# **Request for Proposal**

## **Dillon School District Three**

### **Telecommunications Cabling for Latta High School New 200 Wing**

January 11<sup>th</sup>, 2023  
Updated 2/8/2023 to Reflect Addendum 1

Page 9

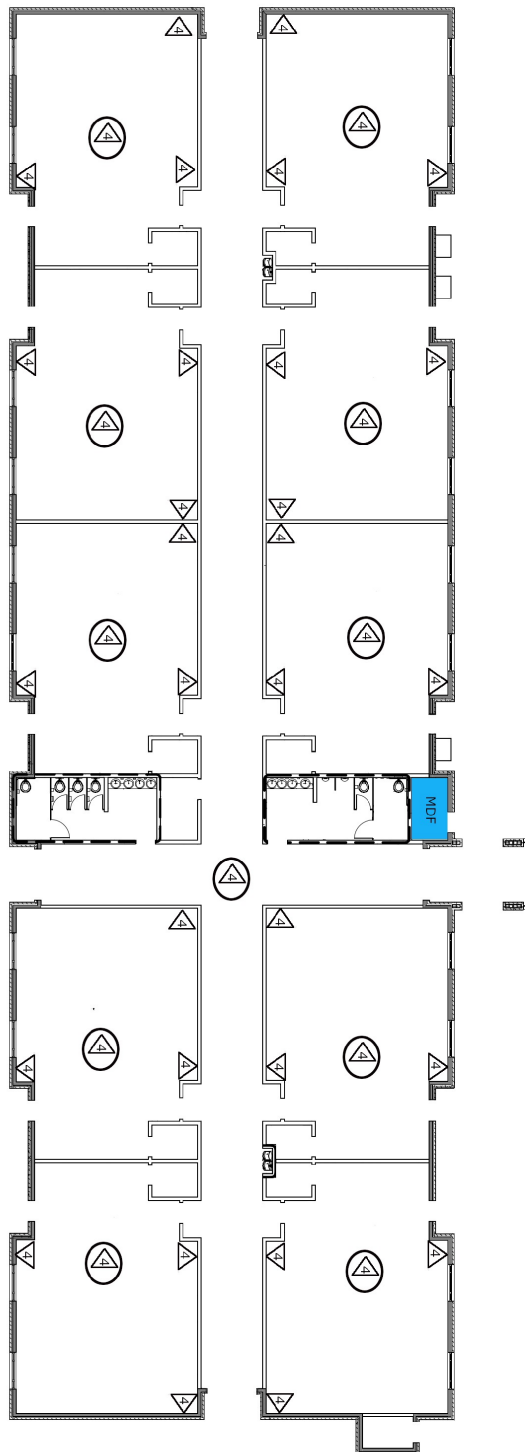
1. Only single mode fiber will be used in the project instead of multimode. *Page 6*
2. EMT can be used in the gymnasium for the runs to the crows nest instead of Rigid. It just can't be PVC or anything like PVC that will bend, sway or otherwise droop to look "bad" in the future. *Page 6*
